Replacing Drive Nuts on 550lb Capacity Trus-T-Lifts Additional Note on Backwards Compatibility

Aug, 2014

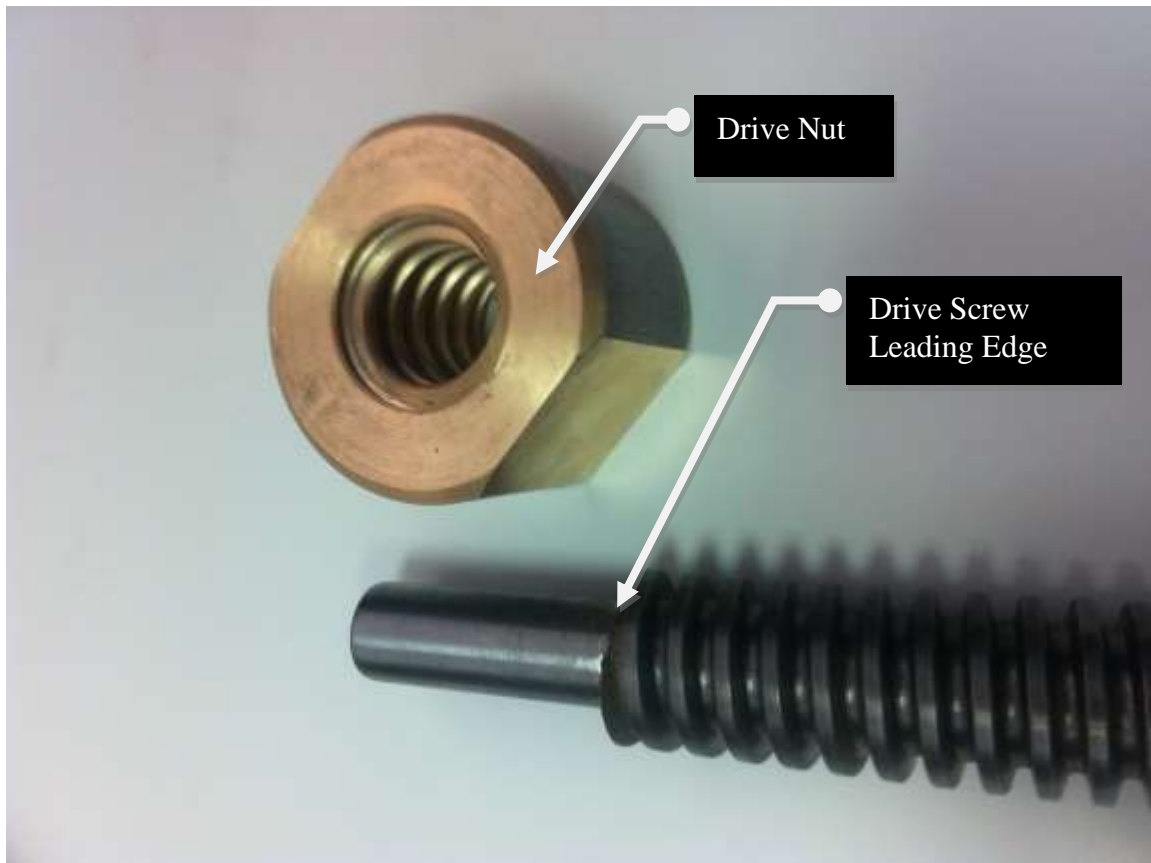
RAM's Trus-T-Lift product is built on an ACME screw and nut drive system. The screw and nut, as shown in the image below, interface directly to hold any load being carried by the lift.

RAM is always improving our products and at one point the tolerances for the drive nuts were altered to improve the performance of our Trus-T-Lift product. This caused a small backwards compatibility concern that may cause new drive nuts to not fit properly when being installed during maintenance.

The fit of the new style of drive nuts has been altered slightly and in order to have them fit the original drive screws the leading edge needs to be filed down slightly with a fine grain metal file.

This only needs to be done on the initial lead edge of the drive screw and care should be taken to avoid damaging other threads.

Filing should be done gradually with intermittent checking of the fit progressively until smooth thread start is achieved.
